NORTH FALLS

Offshore Wind Farm

Applicant's Response to Secretary of State's Letter dated 18 December 2025

Document Reference: 11.7
Volume: 11
Date: January 2026
Revision: 0

Figure 1. RTD density surface used to define the location of the OTE SPA boundary. Figure reproduced from Fig. 2 in O'Brien et al., 2012 to also show the area of overlap with the North Falls OWF 12 km buffer and 1km intervals³.

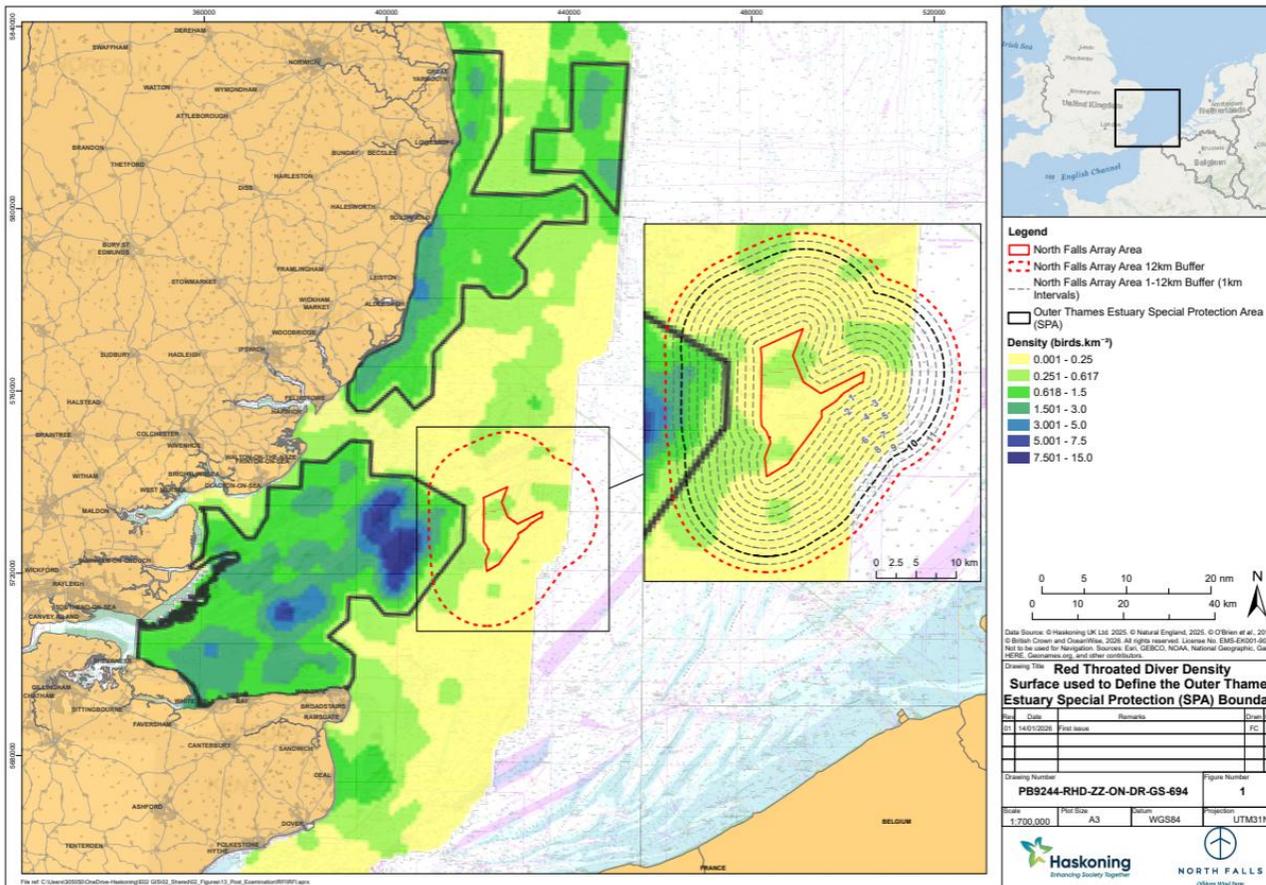
4. The RTD density surface shows some high-density areas (in blue) and lower density areas (yellow and green). Maximum curvature was used to identify a threshold density for drawing the SPA boundary, of 0.618 birds.km⁻² (O'Brien *et al.*, 2012)⁴. All cells with a value greater than this threshold density were included within the SPA boundary. The boundary was drawn to be as simple as possible, following lines of longitude and latitude (O'Brien *et al.*, 2012). This meant that some lower density areas (i.e. below the threshold value) were also included within the SPA boundary.

6. In Figure 1, it can be seen that the boundary includes some cells with a density less than the threshold, in the area overlapped by the North Falls OWF 12 km buffer. These cells are indicated by a strip of paler green at the western edge of the OTE SPA boundary closest to the North Falls array. Had a more complex boundary been drawn, which did not follow the lines of latitude and longitude, these cells would not have been included within the SPA. This does not mean that the OTE SPA boundary is 'incorrect', but that it does include areas of low RTD density, as well as high density areas of national and international importance. The Applicant notes Natural England's statement
